# Lightning Protection Systems

## ATLAS Enquiry Cases

The following enquiry cases have been received by the ATLAS Lightning Protection Committee regarding the interpretation of BS EN: 62305, the recognised British Standard for the design, installation and testing of lightning protection systems.

## Ref. 06: Ridge Conductor (4 December 2009)

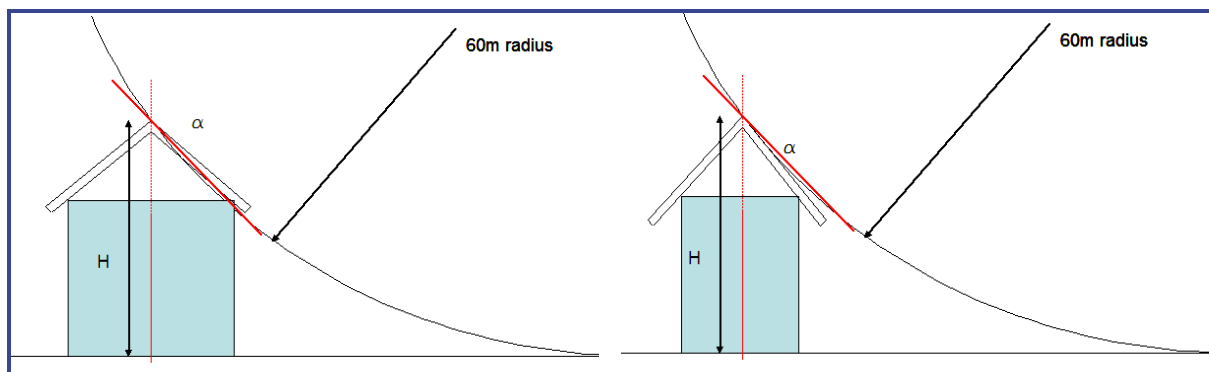
Will a ridge conductor offer protection over the eaves of a pitched roof?

There are three methods of providing protection: the mesh method, the protective angle method and the rolling sphere method. One or a combination of these can be applied to the design process. In this case, the protective angle method would be applied on its own. The designer would need to look at the reference plane on relation to the ridge conductor and carry out the assessment as per Part 3 Table 2.

E.14, 15 and 16 show various scenarios using the protective angle method on pitched roofs but does not appear to offer an example using just a ridge conductor. However ignoring the fact we have an eave at all, the angle of protection will apply in all cases (see below).

The area under the zone of protection is the same with or without the eave, with respect to the rolling sphere we can see in the above example how it may also offer protection to the eaves. The above example also shows a shallower pitch where eaves protection would be needed.

## Ref. 22: Use of Re-bars in Structural Reinforcing as the Down Conductor (29 August 2013)

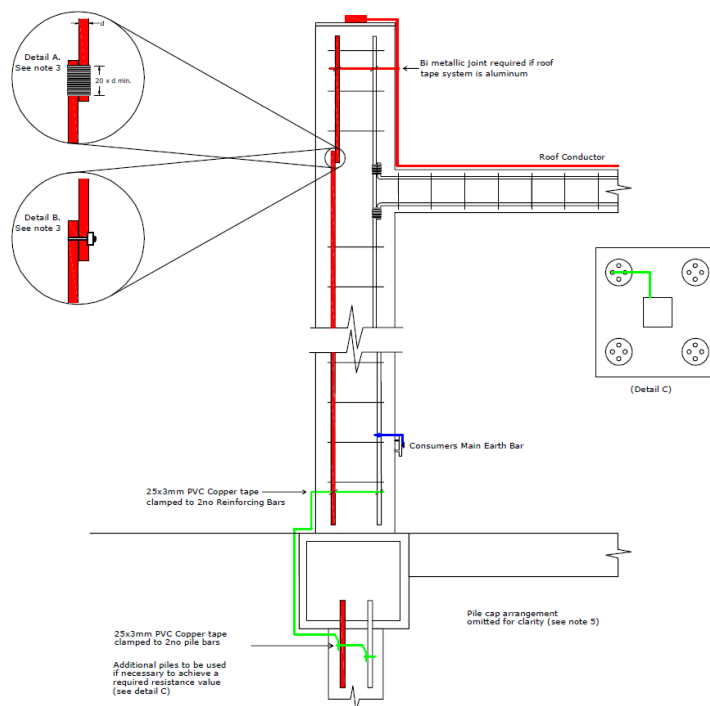
When utilising the cast in-situ structural reinforcing as the down conductor, please clarify the method, type and quantity of the connections to, and between, the re-bars.

BS EN 62305-3:2011 E.4.3.3 defines the method, dimensions and quantity of connection methods.

For the purpose of carrying lightning current, the available options to provide electrical continuity in a re-bar are illustrated in BS EN 62305-3:2011 Figure E.5 and are defined as;

1. Welded connections (with a minimum weld length of 50 mm)
2. Clamped connections (with components conforming to IEC/BS EN 65265-1)
3. Bound joints (overlapped 20 times the rebar diameter and fully bound along this length)

For connections to and from the re-bar at, say, roof and ground level there shall be two conductors connecting to different re-bars or one conductor extended to connect to two different re-bars.
